TOWN OF BRIMFIELD

At the request of the Selectboard, I have reviewed all documents in the Building Department file pertaining to the Town of Brimfield Annex Building and its structural condition.

Re: Structural Condition Survey
Town Hall Annex
Brimfield, Massachusetts

Re: Structural Review
Town Hall Annex
Brimfield, MA

Photograph #25 - Bowed Front Exterior Wall

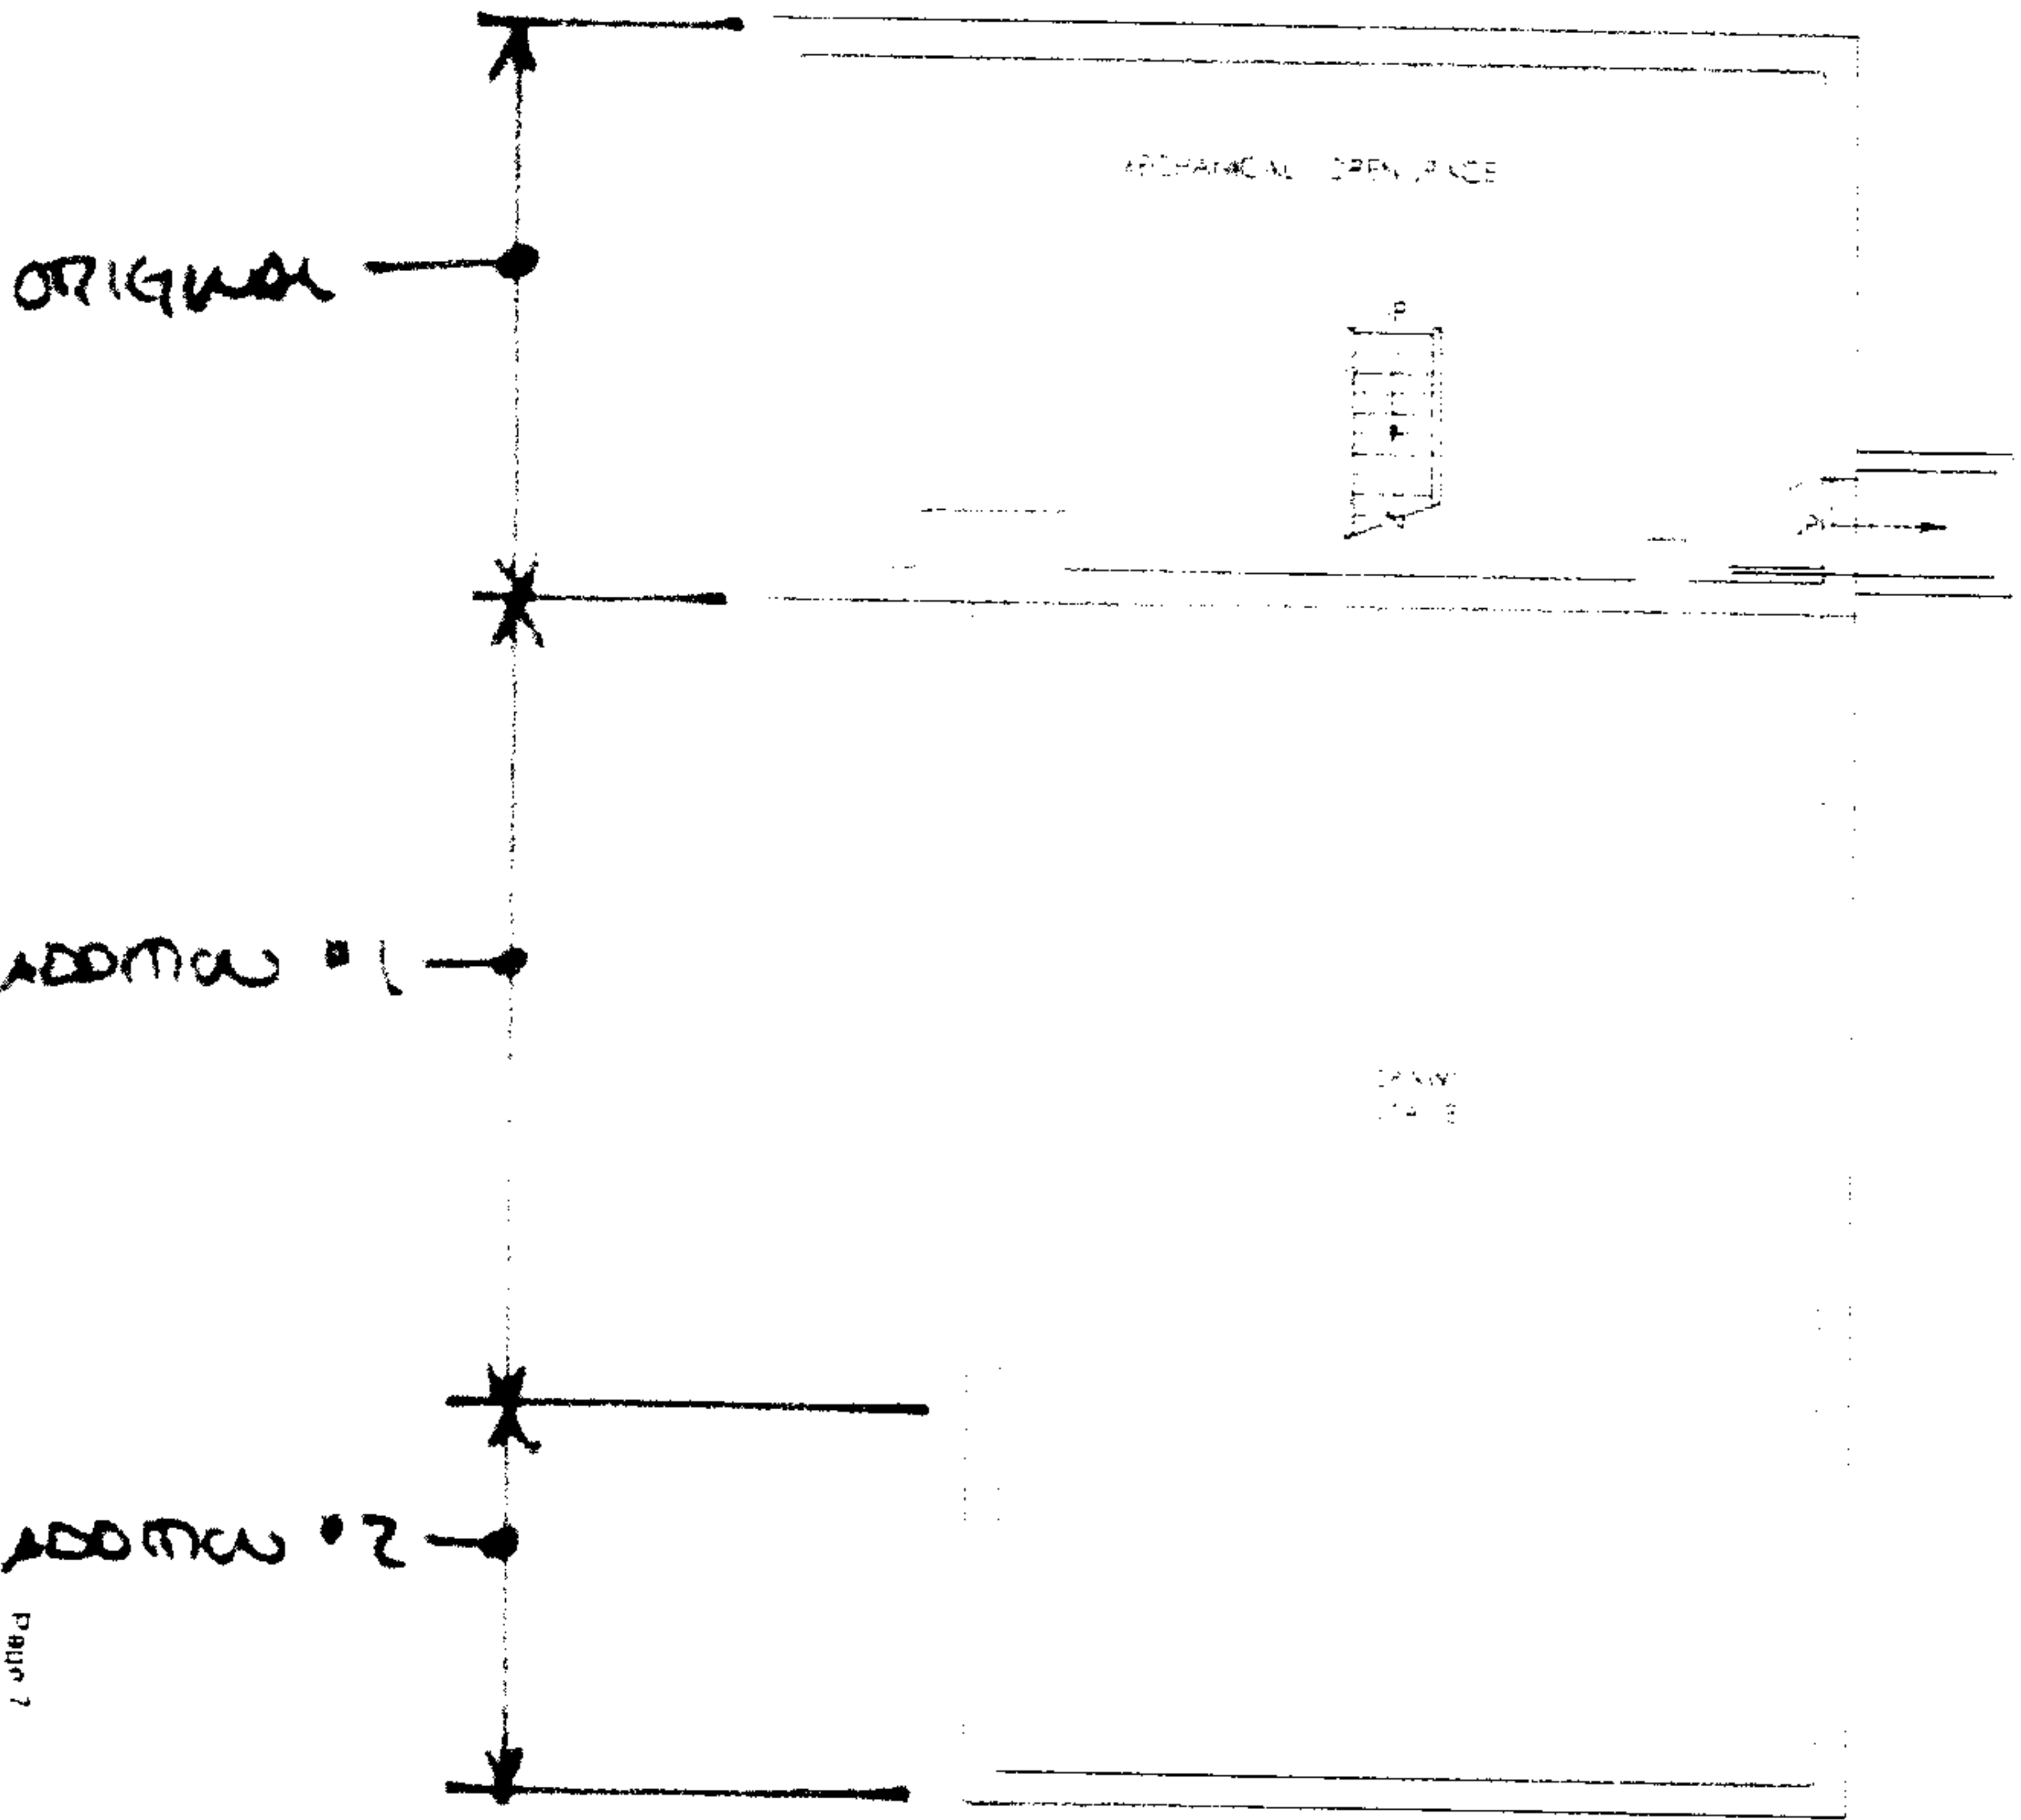
19. There is a large bow in the front exterior wall adjacent to the front door (see photograph #24 and #25).
